CITY OF ALBUQUERQUE

RE: **La Madeleines**
2110 Louisiana Blvd NE
Grading Plan and Drainage Report
Engineer's Stamp Date 12/12/2016 & 1/3/2017 (File: J19D071B)

Based upon the information provided in your submittal received 01/03/2017, the Grading Plan and Drainage Report are not approved for Building Permit. The following comments need to be addressed for approval of the above referenced project:

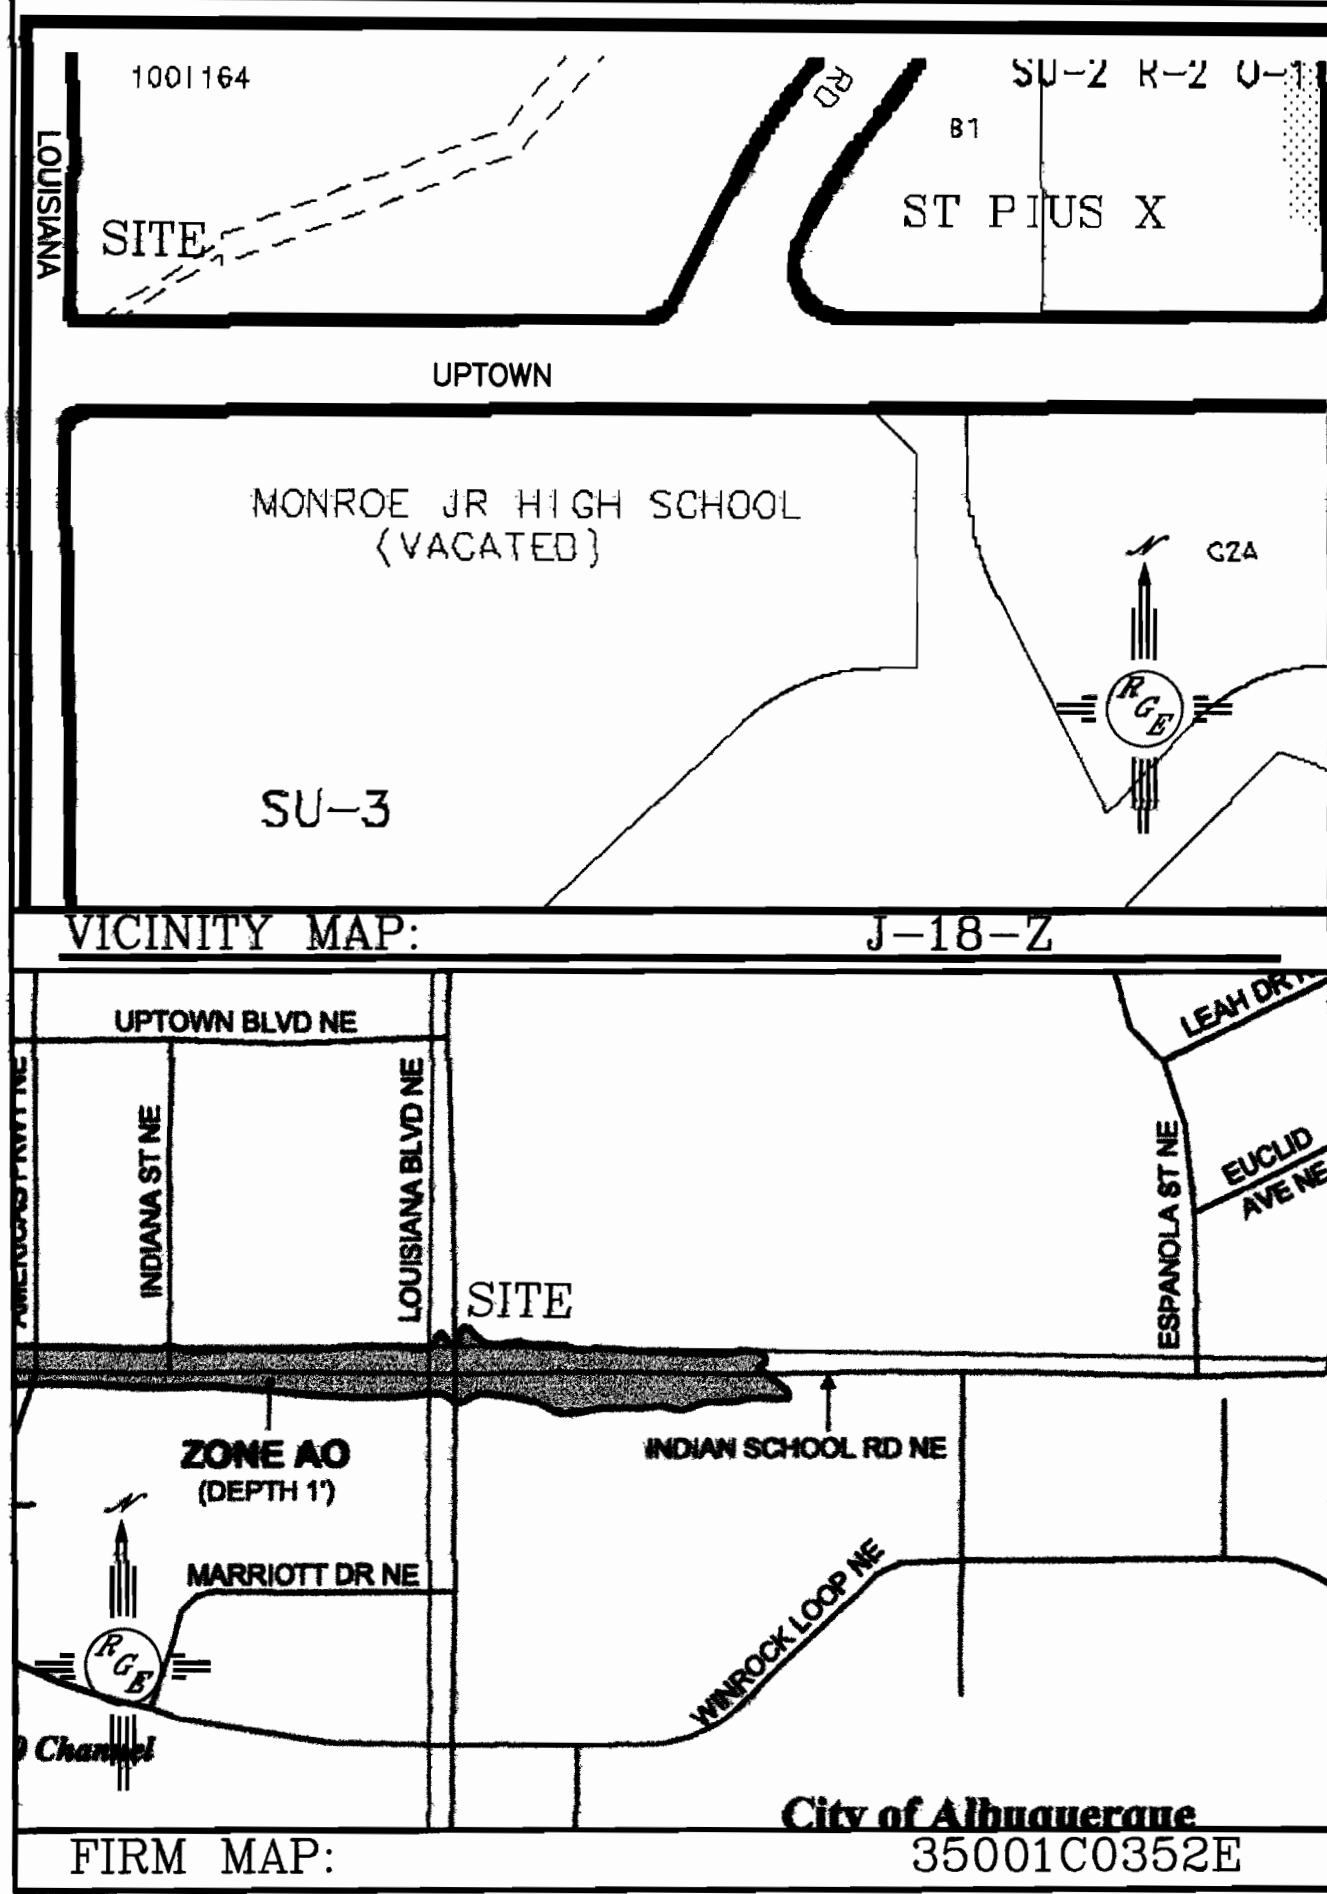
1. Center the viewports for the Vicinity Map and FIRM Map on the site and label the correct site location.

ENGINEER'S SEAL	LA MADELEINE		DRAWN BY: WCW/J
	GRADING AND DRAINAGE PLAN		DATE 12-12-16
DAVID SOULE P.E. #14522	 <i>Rio Grande Engineering</i> 1606 CENTRAL AVENUE SE SUITE 201 ALBUQUERQUE, NM 87106 (505) 872-0999		SHEET # C001 JOB # 21634

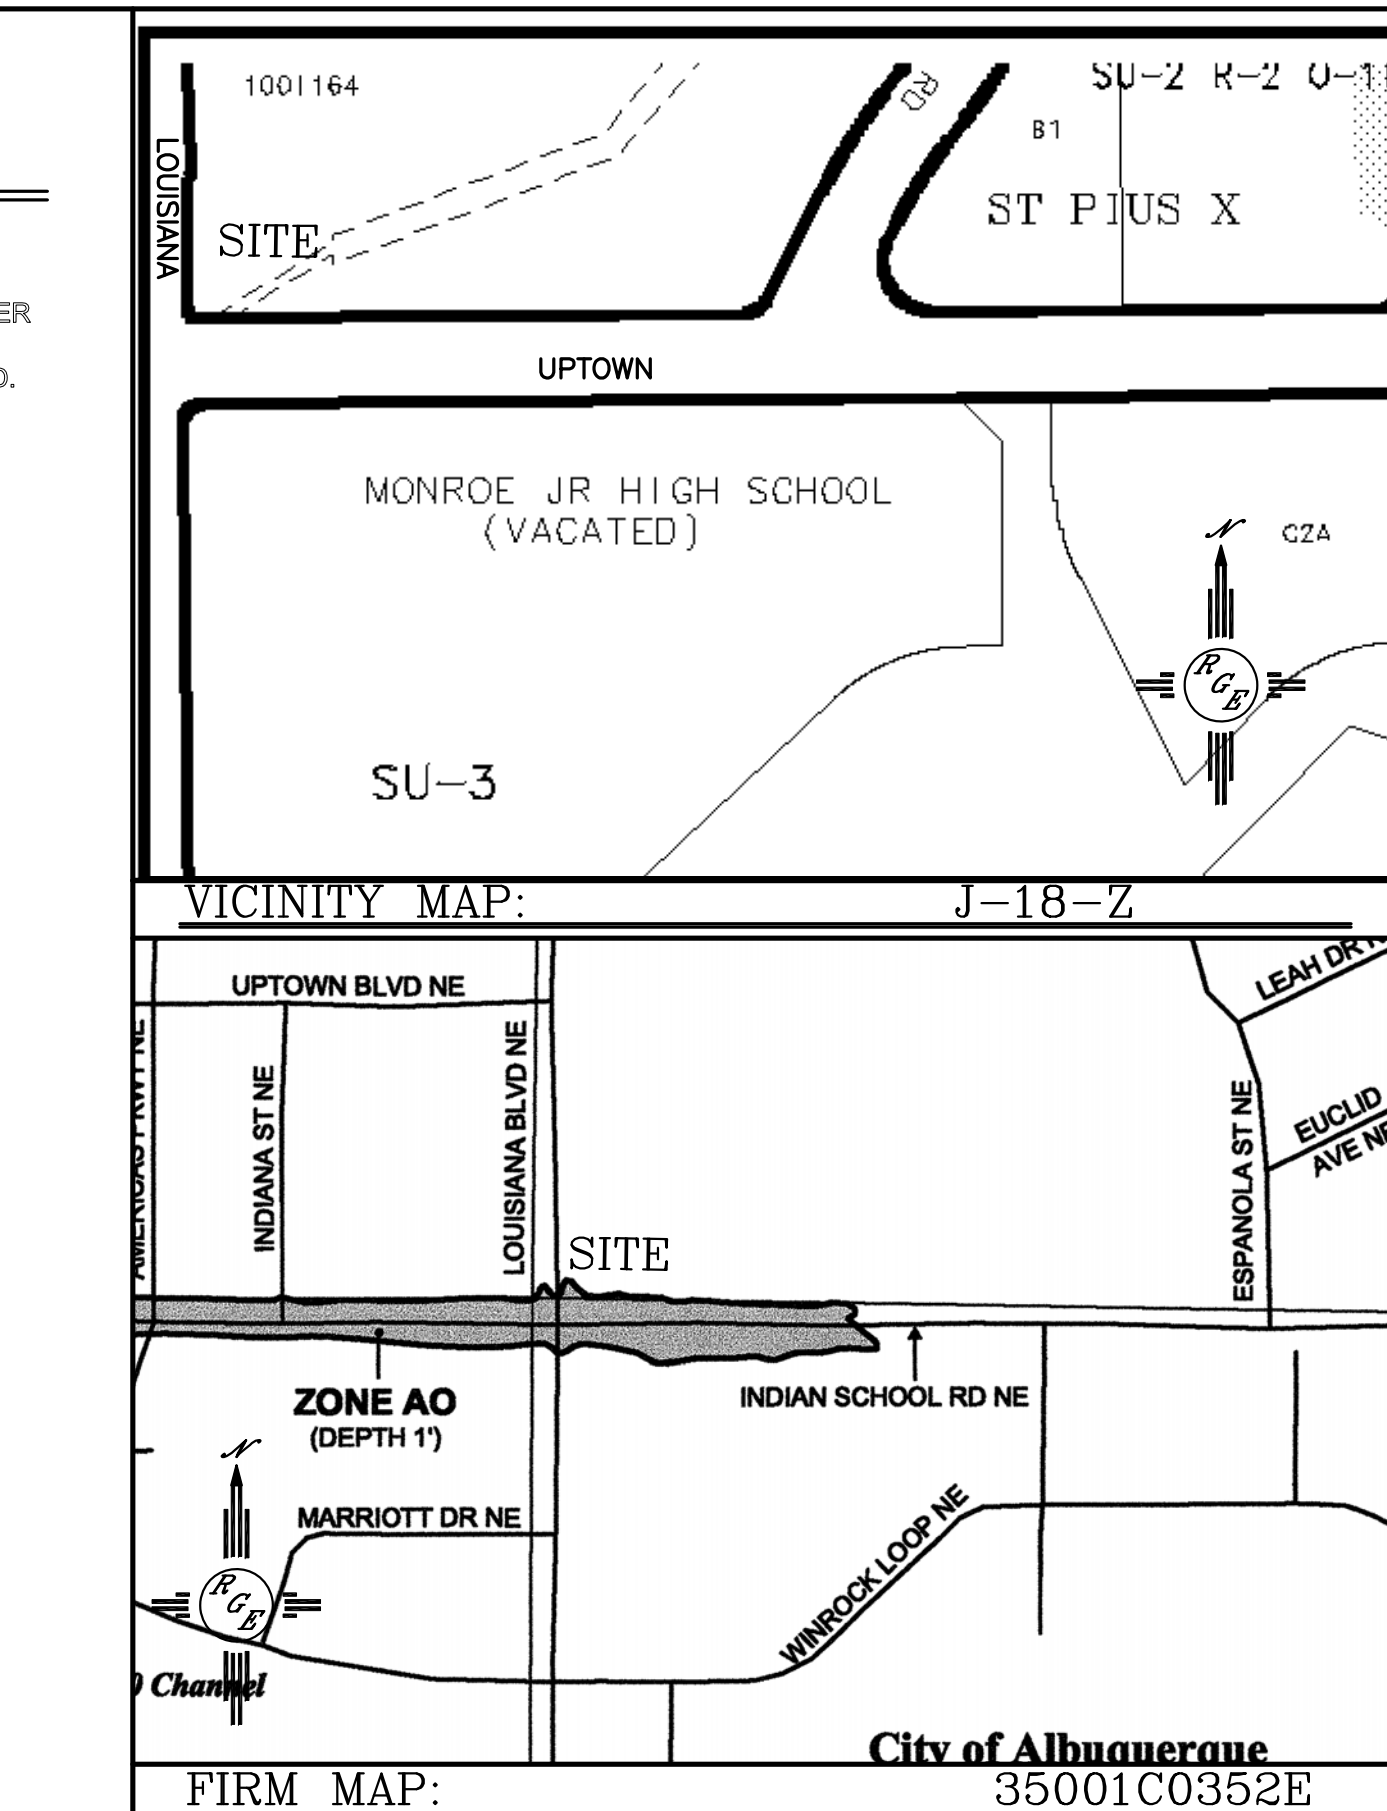
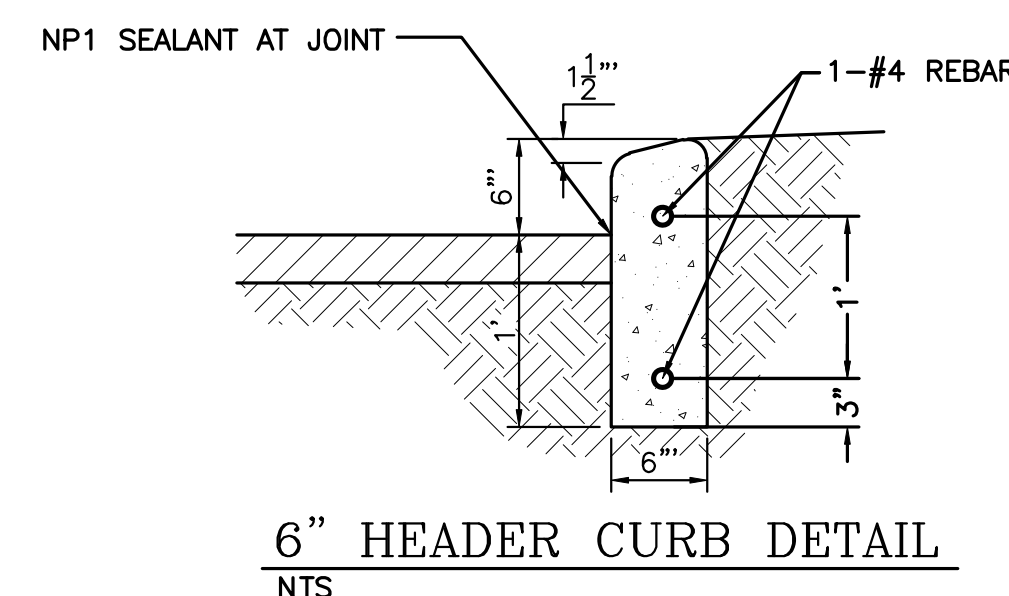
1. First Flush Storm water quality standards do apply. Detention of the first flush volume, indicated as 133 cf, is required.
2. The inlet at the southwest corner is proposed to be removed and extended, but it's not defined where the new one will be placed. Extending the line towards Uptown Loop appears to put it in conflict with the existing sidewalk, the retaining wall and its footer, and any utilities that may be there. Another option may be to remove the inlet and storm drain back to the manhole, and replace with a new inlet and storm drain running south towards the intersection. This would avoid the retaining wall and slab all together.

3. Analysis of the private storm drain system showing capacity of the system due to changes in flow paths is required. Additionally, show flow directions from the roof and for the regraded site.

4. The drainage area for the dumpster will need to include a grease trap and be routed into the sanitary sewer system.
5. Are there any existing sidewalk or utility easements for this site?
